Blue Print

AD07R1785, AD07R2264

Honda Accord CN1/CN2 2003>08; CR-V RD9/RE6 2005>08; FR-V BE5 2005>08

Auxiliary drive belt

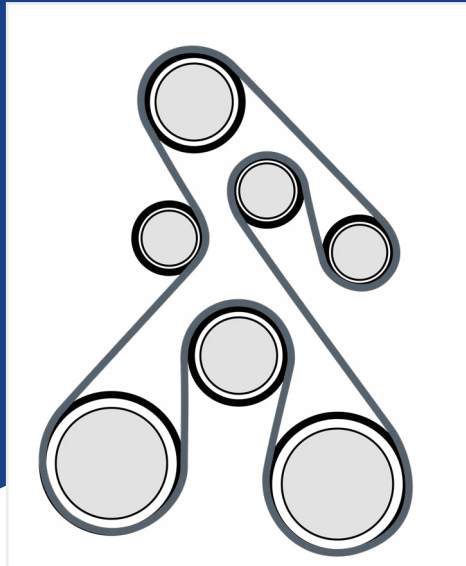
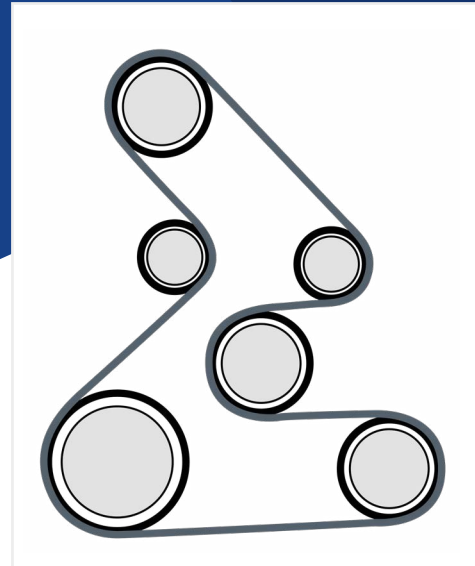
Problem

Whirring or clicking noise from the engine, which increases with engine speed.

Cause

High load on the alternator drive pulley which causes premature wear of the alternator bearing.

Modified auxiliary belt layout, routing and size of the auxiliary drive belt, this is to reduce the stress on the alternator bearings.

The modification involves completely removing the upper idler pulley, and replacing the original 2264mm belt with a shorter 1785mm belt which is re-routed as per the diagram above.

When replacing the auxiliary drive belt it is advisable to check the alternator bearings by rotating the pulley and checking for any roughness or noise, and replacing the alternator if necessary.
